Access Compliance Report

Public Rights-of-Way

(Curb Ramps)

Intersection ID: 28030	Main Street: CHEVIS_CT	Cross Street: LEGACY_CR	Location: SW
ADA ID: 964B0E5B9462	Ramp Type: BlendTrans1	Initial Pass/Fail: Fail	Overall Compliance: No
		Severity Score: 35

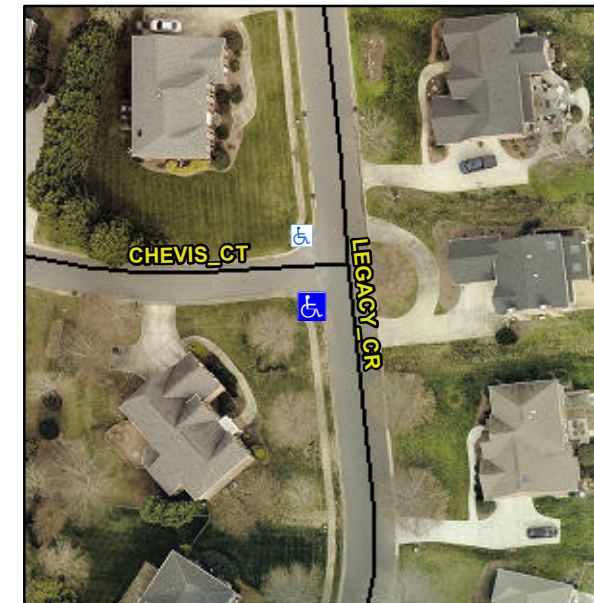
NO RT SW

Not Found, R304.5.1

Remove & Replace Curb Ramp With Two New Directional Ramps or Equivalent.
